LUSCOMBE AIRPLANE CORPORATION
DALLAS, TEXAS

SERVICE BULLETIN 5-46

SUBJECT: Installation Battery Cable Clip
Fwd Sta. 2 R.H. Side (R.H. Side Door)

MODEL: 8E Opt. only.

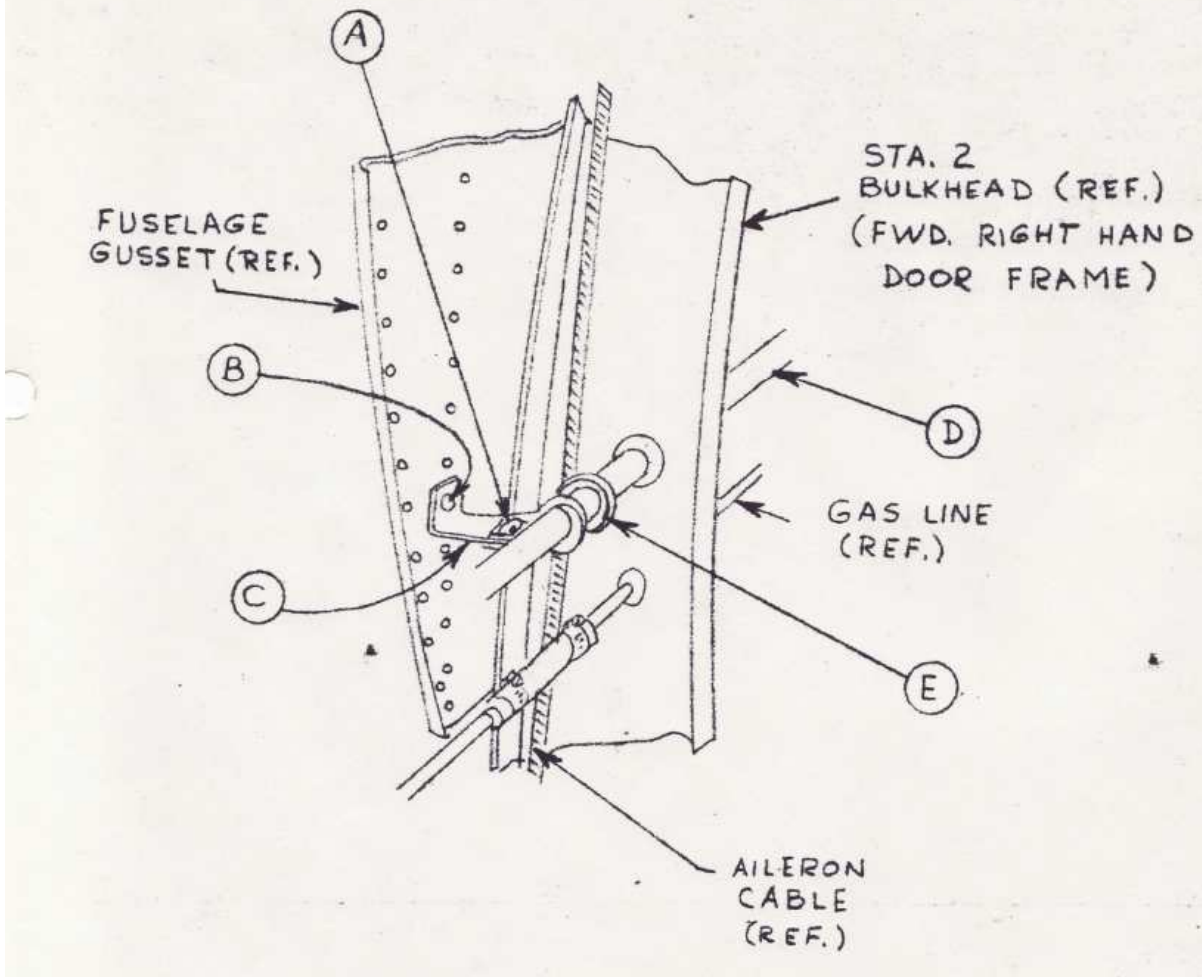
To preclude possible short circuiting of the Battery Cable, the following action is to be incorporated in the subject aircraft at the earliest possible moment.

1. Remove R.H. Kick Panel
2. Drill out Rivet as shown on sketch
3. Install Angle Clip with Rivet
4. Install Clamp to Clip with Nuts and Screws
5. Clean out Area
6. Install R.H. Kick Panel

Remove Rivet; as shown (B) (sixth Rivet from Bottom of Fuselage Gusset).
Install AN & Luscombe Parts as shown.

- (A) AN3-3 Bolt
AN960-10L Washer
AN365-1032 Nut
- (B) AN456AD4-4 Rivet
- (C) 186123 Clip
- (D) Battery Cable
- (E) AN740-10C Clamp
